Action ID: SAW-2005-21386

Subject: Modification to the 401 Water Quality Certification Pursuant to Section 401 of the Federal Clean Water Act for proposed Greensboro Eastern Loop from US 70 Relocation to SR 2303 (Lawndale Drive), Guilford County, Division 7. WBS Element No 34821.1.1, TIP Nos. U-2525B and U-2525C. NCDWR Project No. 20130918 ver.6.

**PERMIT DRAWING
SHEET 32 OF 93**

PERMIT DRAWING SHEET 54 OF 93

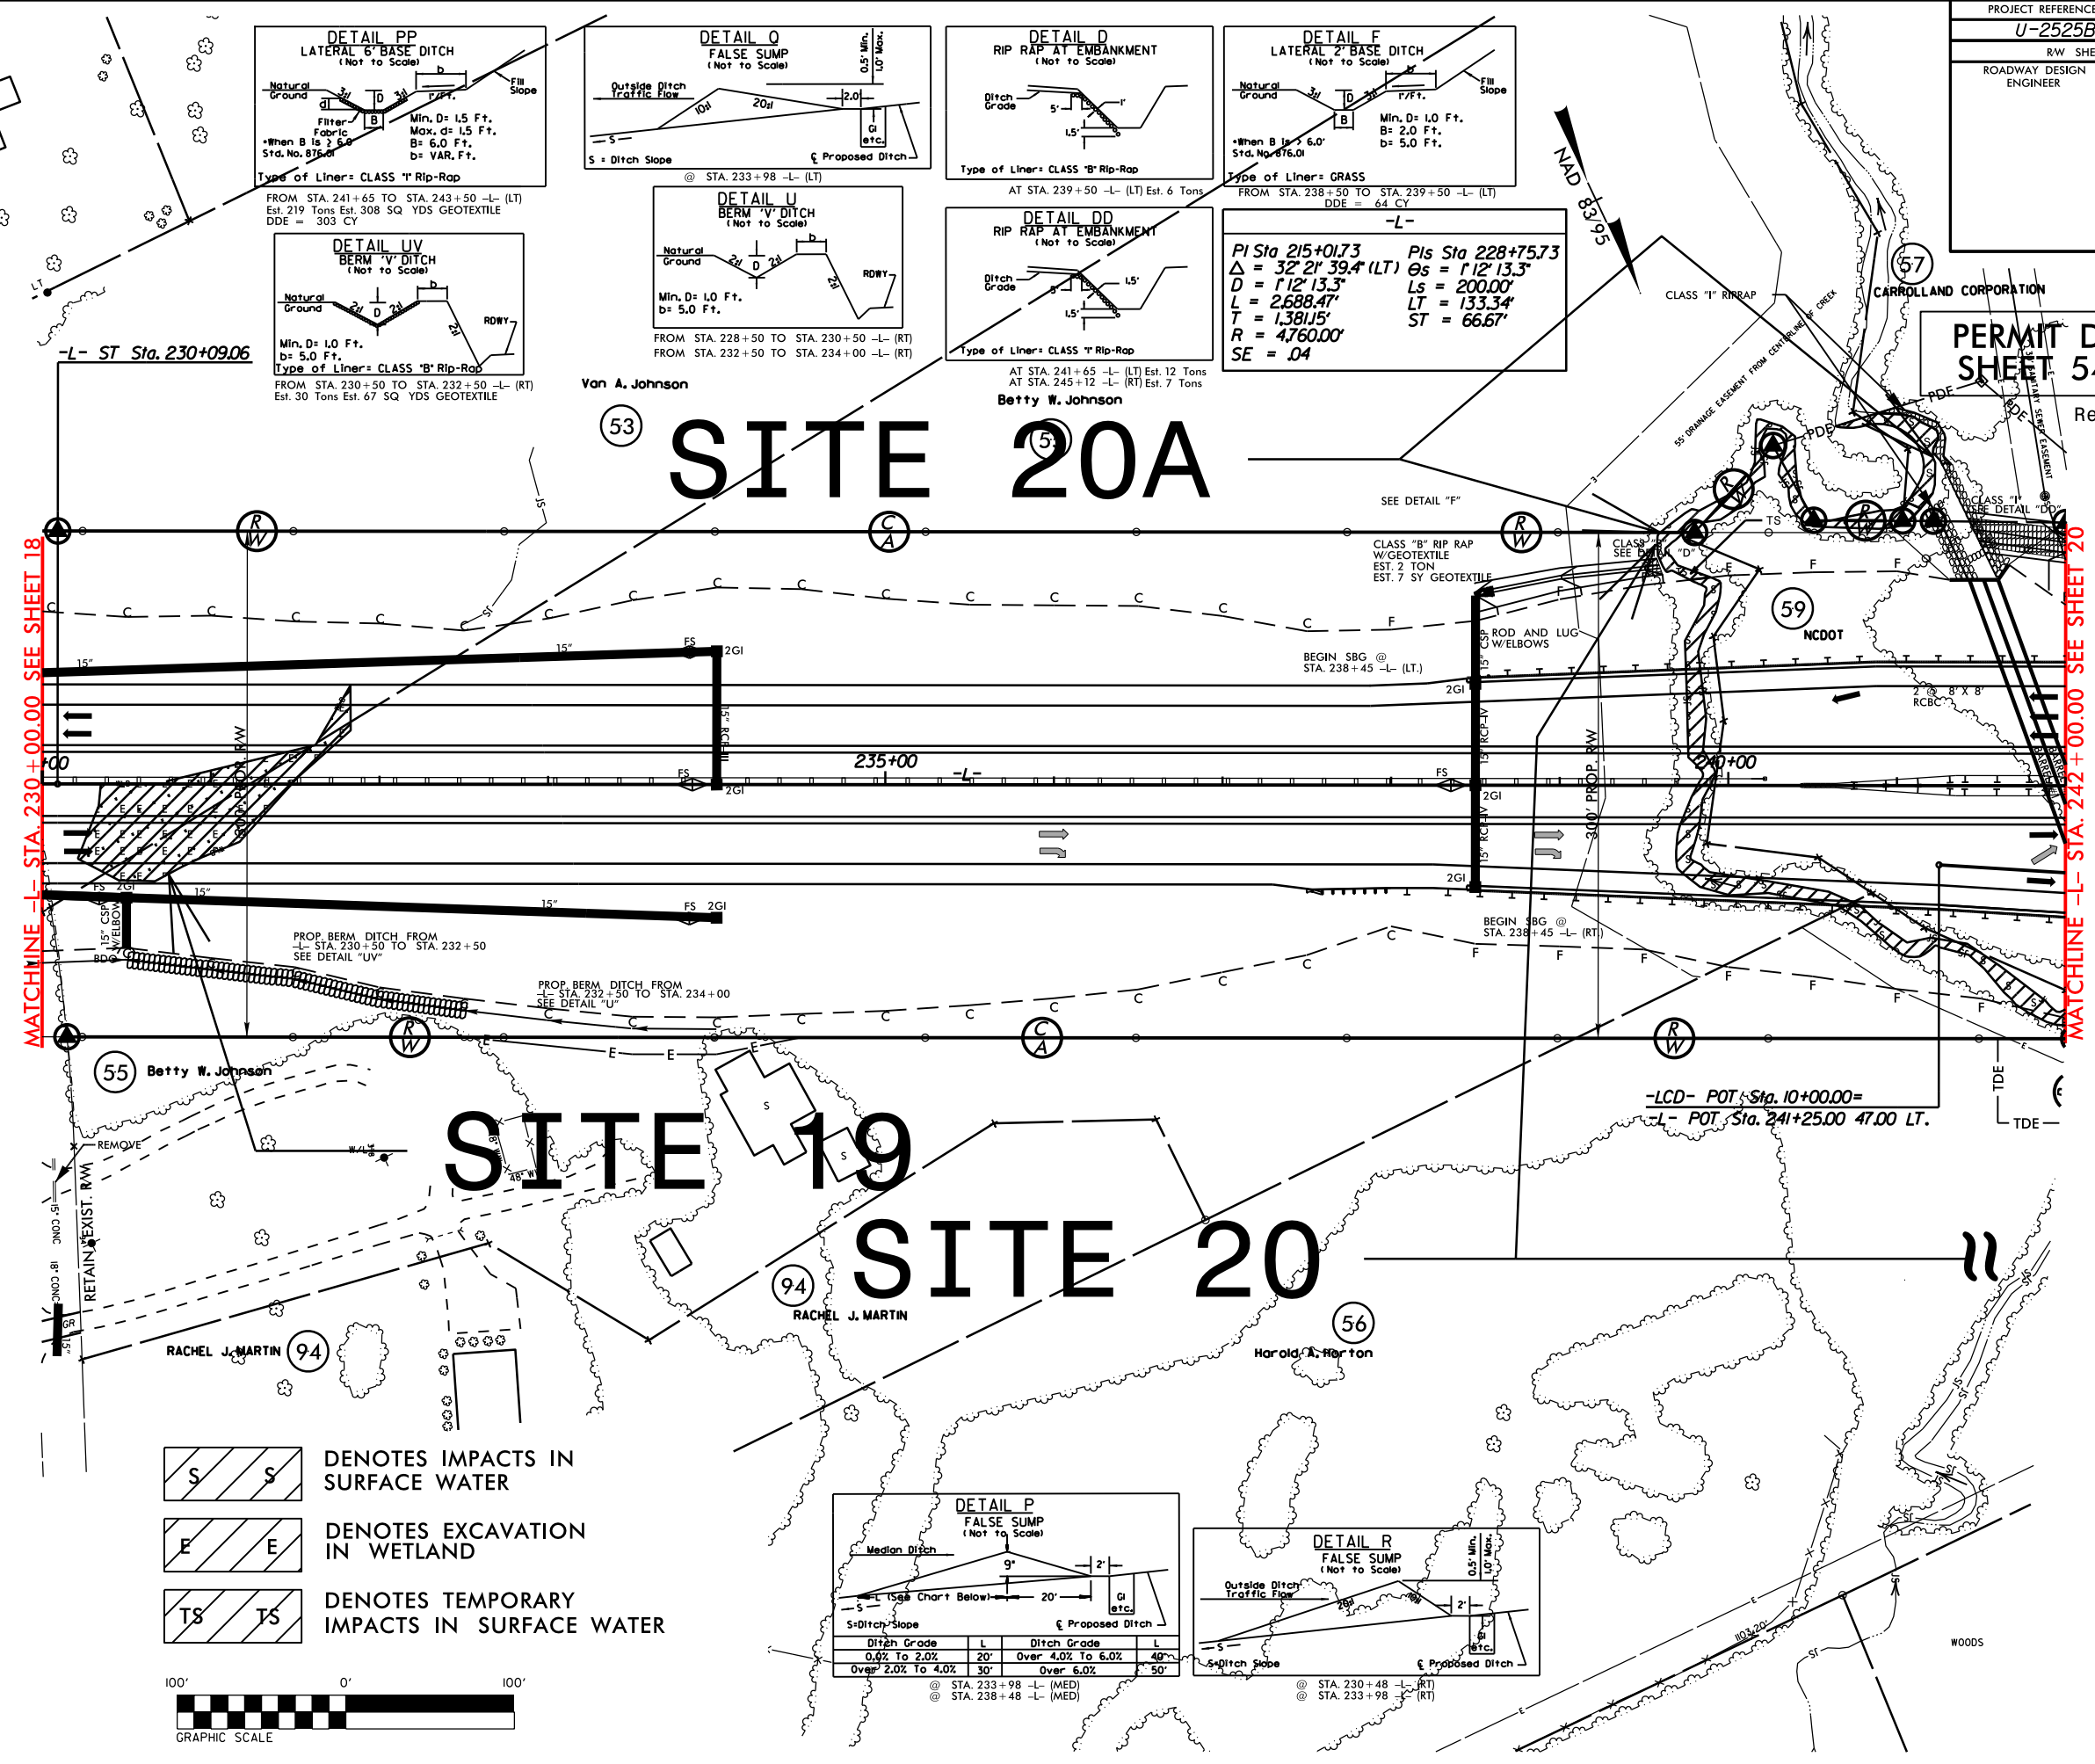
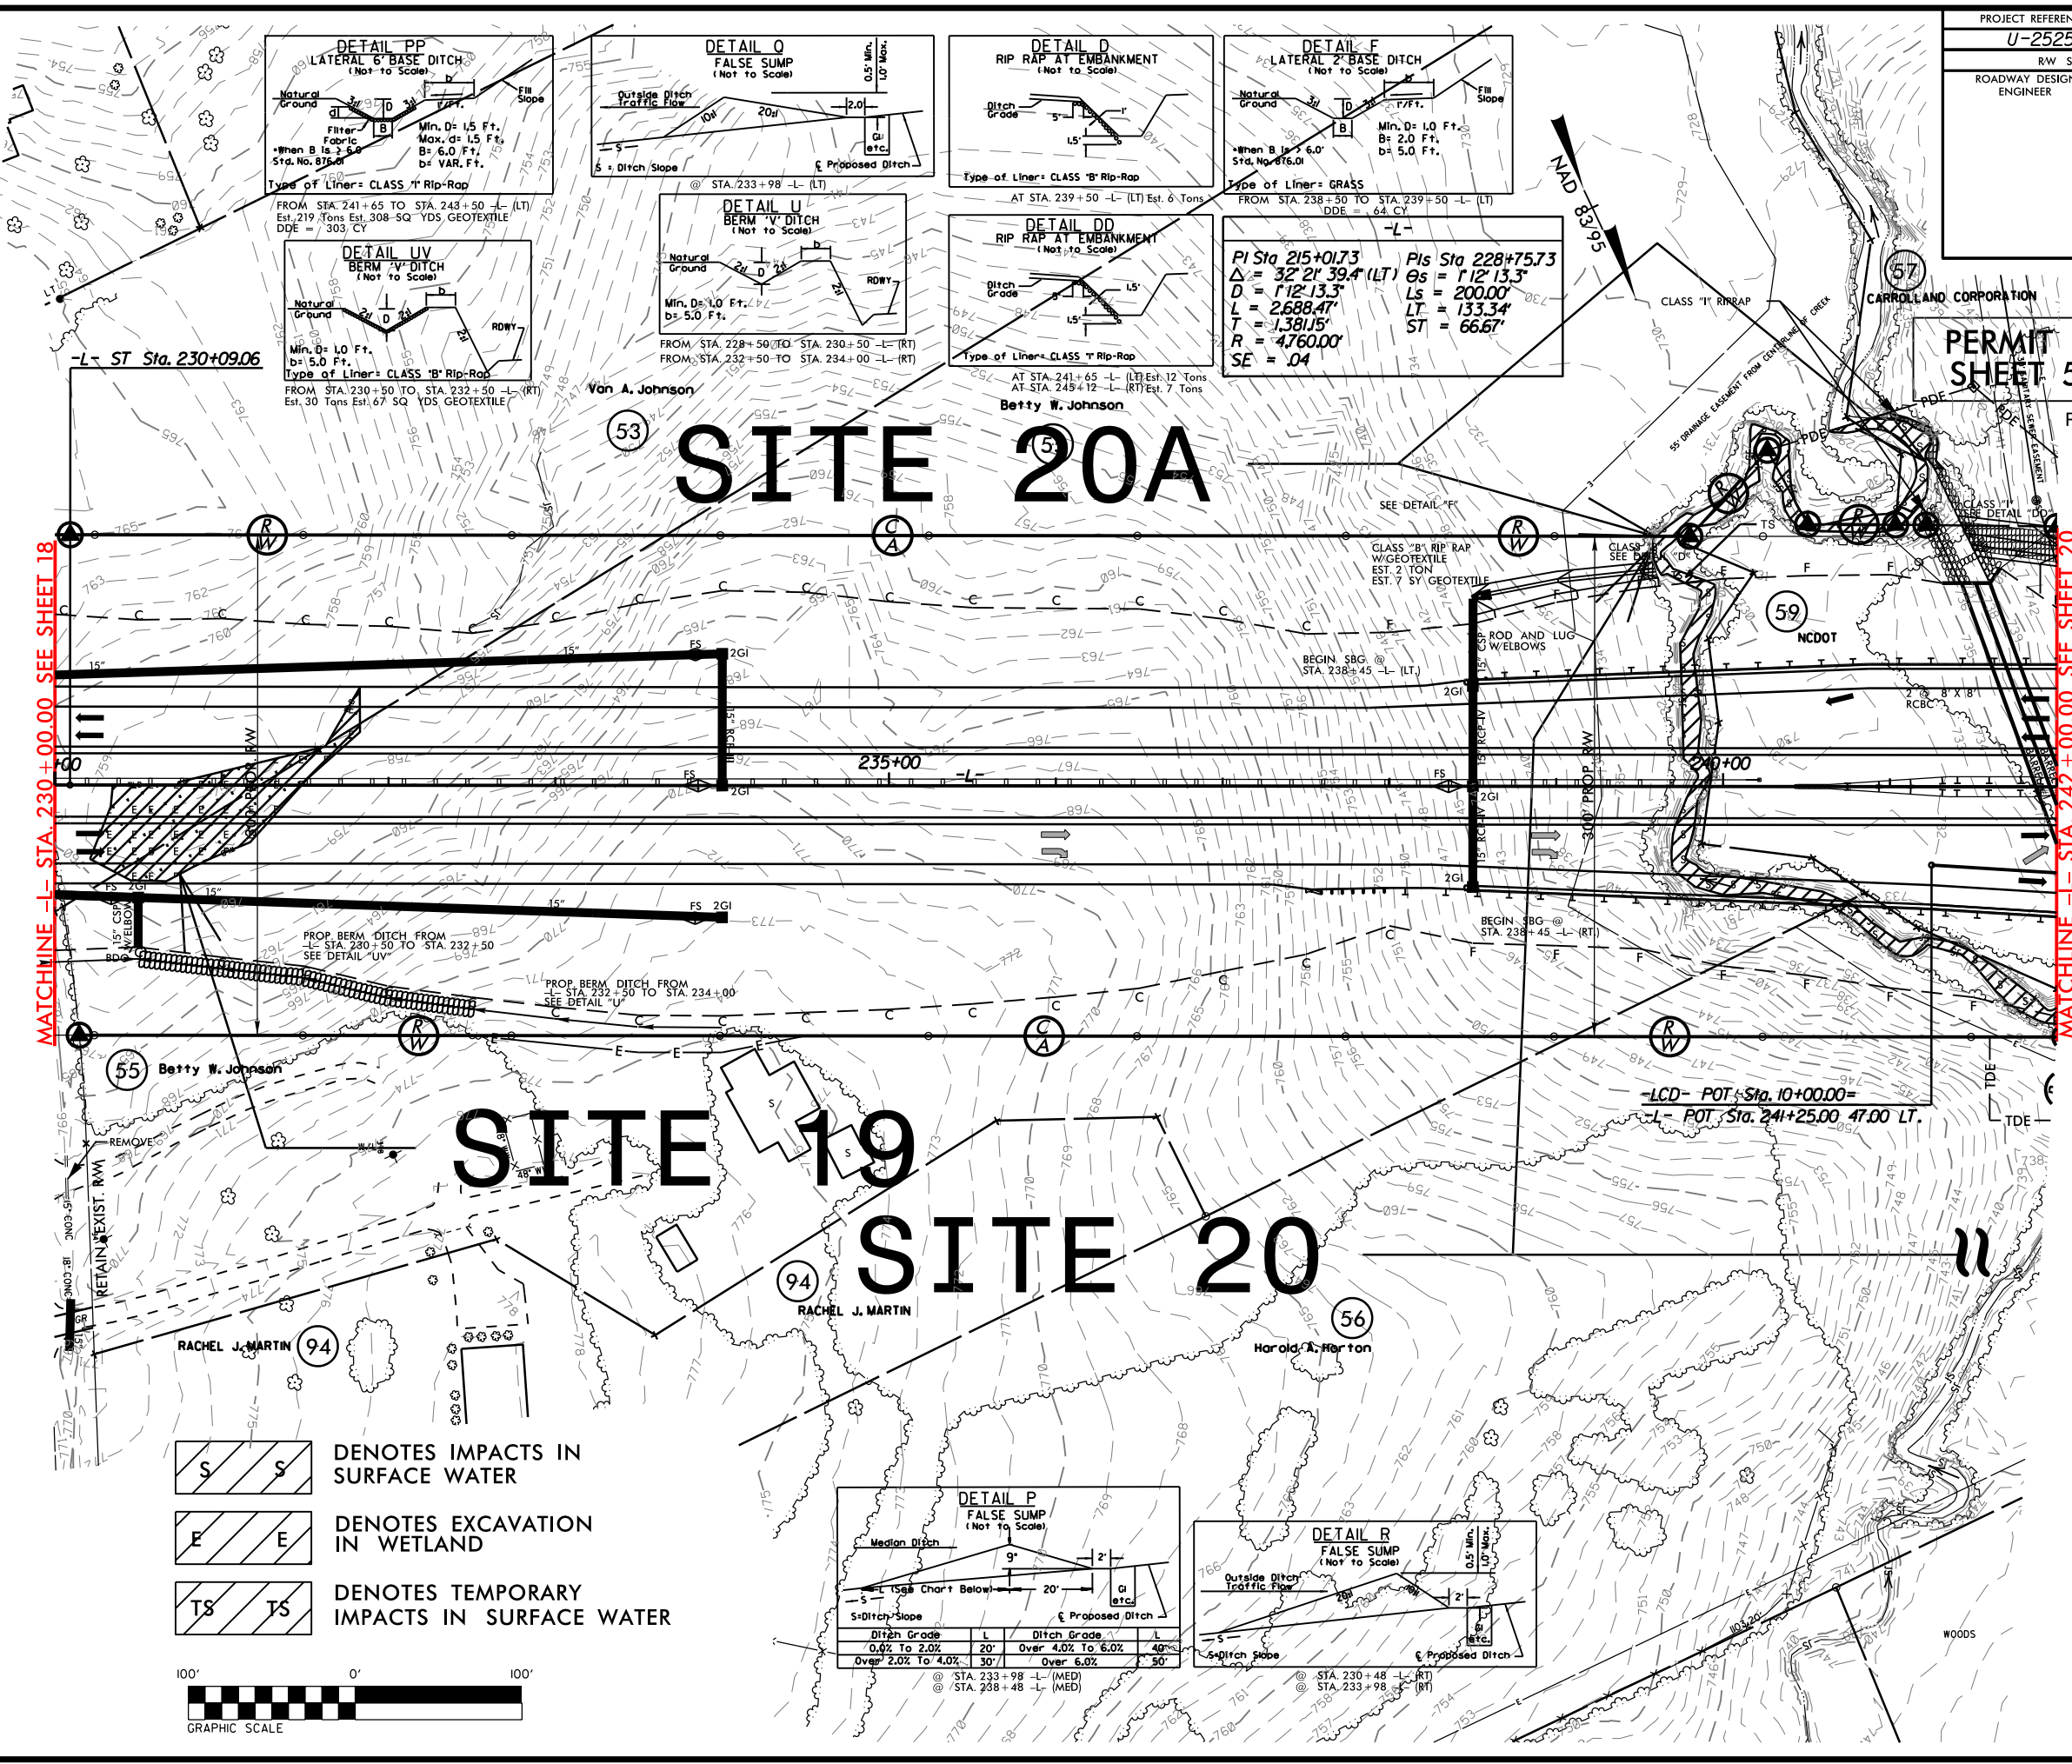
- 4) adding 79 linear feet of rip rap bank stabilization to a stream at Permit Site 20A (replacing 29 linear feet of temporary impacts authorized in the original permit), to account for predicted stream bank instability following release of water into the culvert currently under construction.

Revised 06/22/15
